SERVICE INFORMATION LETTER

Subject: Possible Shaft OD Oversize on Spur Gear PN 422199-100WE

Figure 1, Spur Gear OD Feature

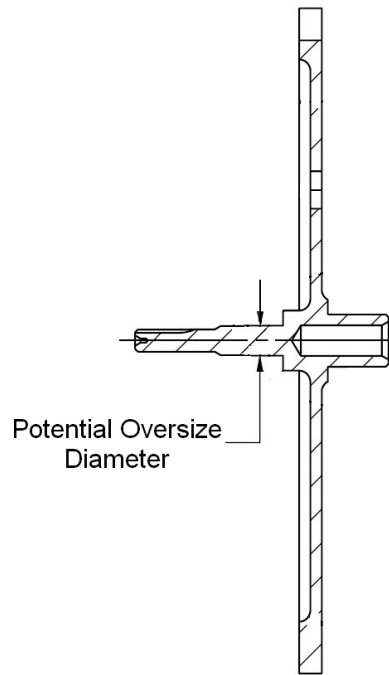
The Wencor design for the subject Spur Gear allowed the possibility of a slightly oversize condition to occur on the outer diameter of the smaller OD shaft on the Spur Gear as shown below in Figure 1.

During the reverse engineering process for the Spur Gear, the size tolerance for the noted diameter was set based upon manufacturing tolerance only. This led to the possibility of the oversize condition by as much as 0.0007", which could prevent installation of the NHA bearing that mates with this shaft. The OD feature has been re-sized to ensure the correct fit under all conditions.

For any Wencor Spur Gear's that are currently uninstalled that have the oversize condition should be returned to Wencor for replacement because this condition most likely prevents the NHA bearing from being installed.

However, any Wencor Spur Gear that are currently installed, passed the ATP for the Trimmable Horizontal Stabilizer Actuator and are in service may remain in service at the discretion of the end user without any change in aircraft safety.
